EH BMP w/ Tone Wicker
 V.0.2 - 5.8.2014
 mirosol/freestompboxes.org

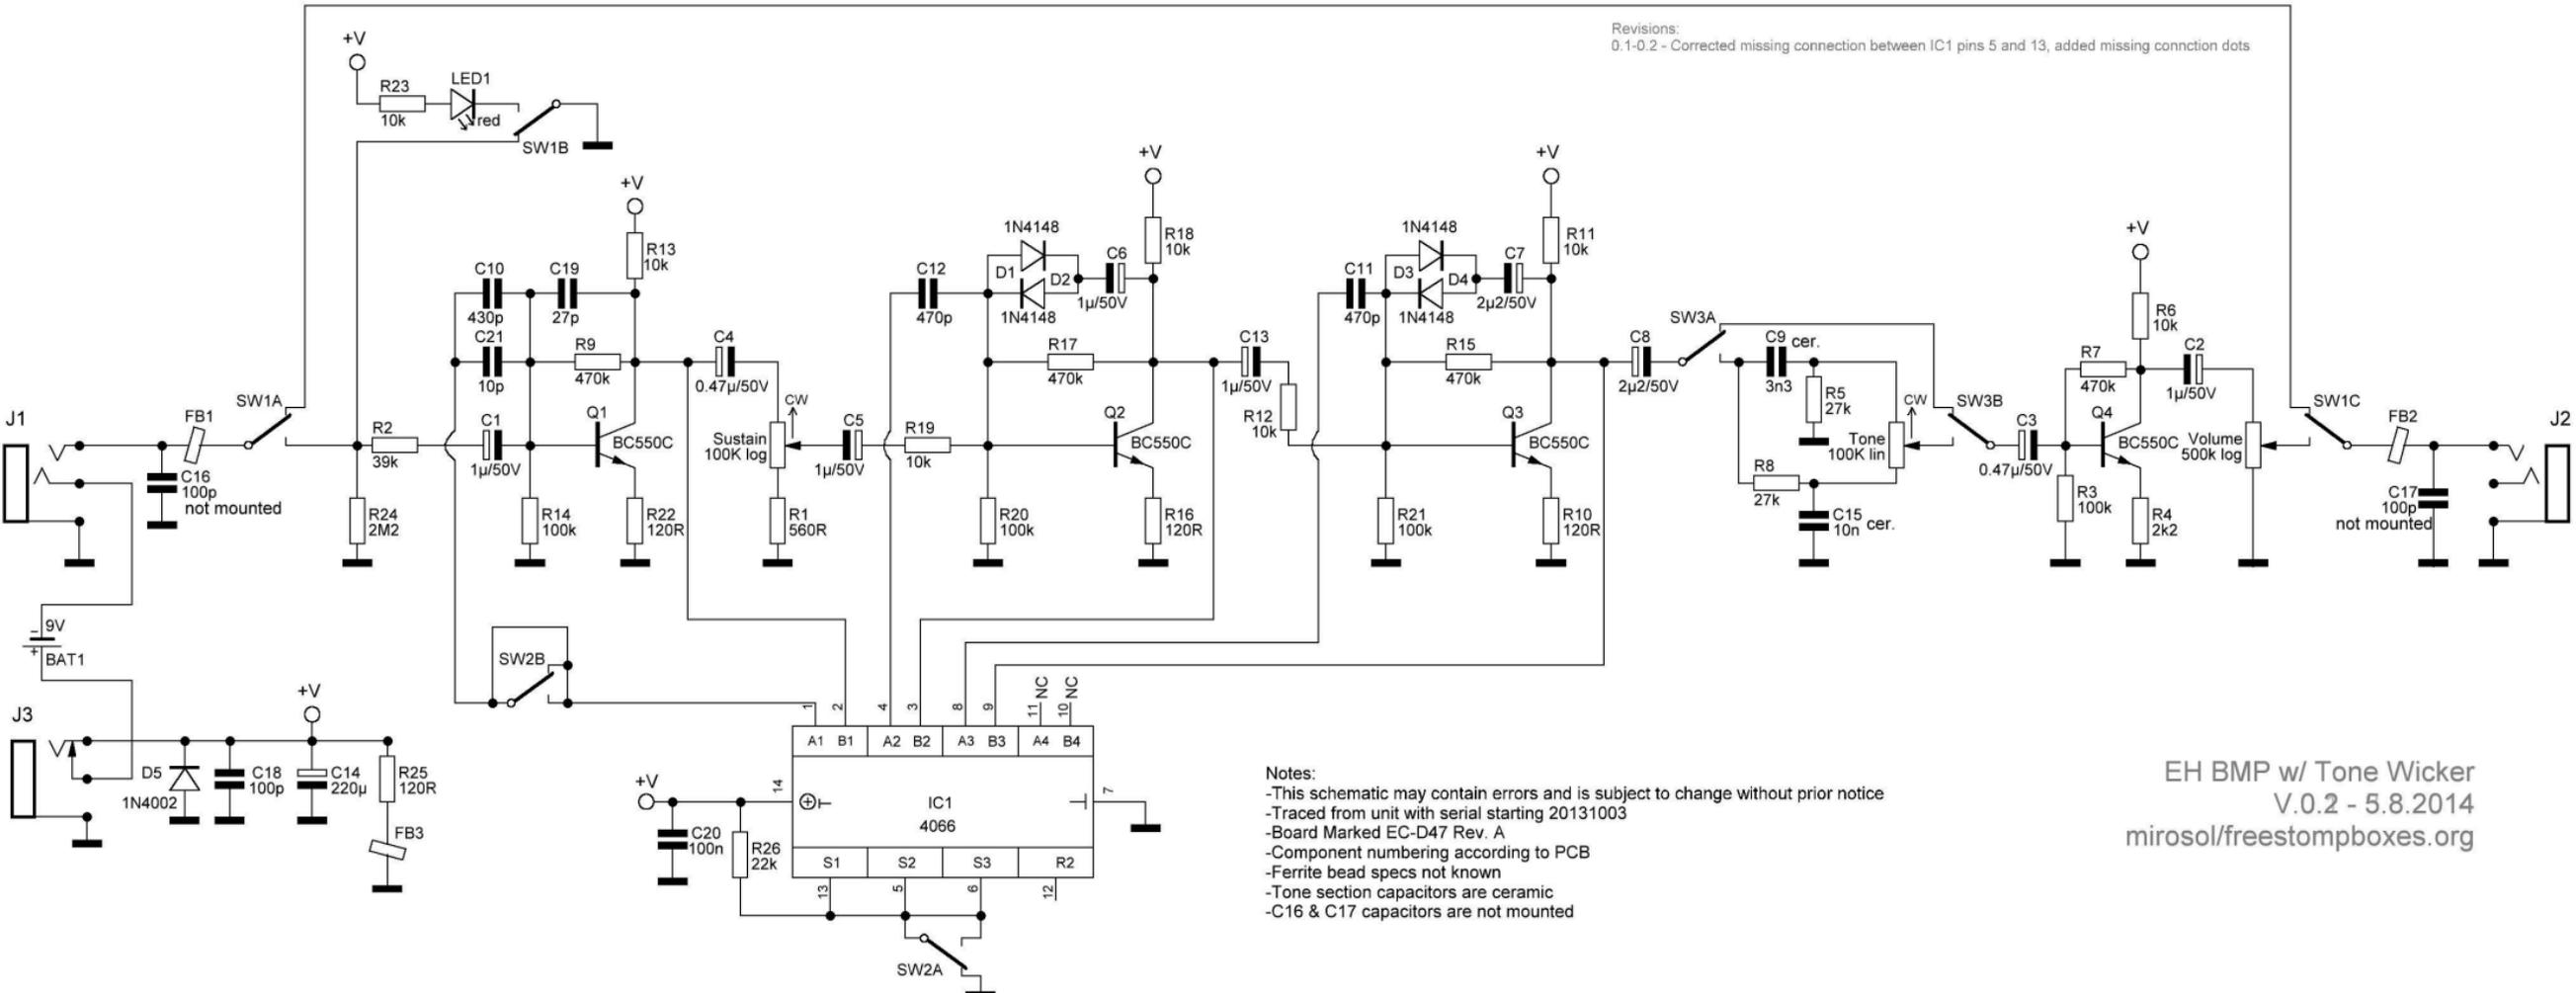
Revisions:
 0.1-0.2 - Corrected missing connection between IC1 pins 5 and 13, added missing connection dots
